PRE-BID REQUEST FOR INFORMATION FORM

Date: 03/31/2025
Company Submitting Request: Dominguez & Persons, LLC
Contact Name: Rafe Stewart Phone: 850-665-2993
E-Mail rafe@ddbconstruct.com
Project Name: Correct FCA Deficiencies in Boiler Plant, Building #14
Solicitation # 36C24725R0071

RFI NO. 007

12 TYPICAL GUY WIRE SUPPORT DETAILS
SS01 1" = 1'-0"

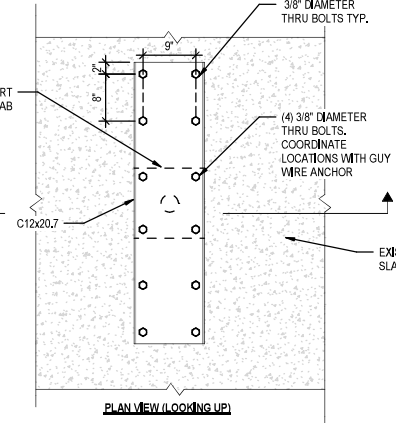
Please advise how many Guy Wire Supports are included.
(Detail is located on structural drawing S501 detail 12). I'm
having trouble locating them on drawings.

Per manufacturer recommendations. We would recommend a minimum of 3 guy
wires per boiler flue.
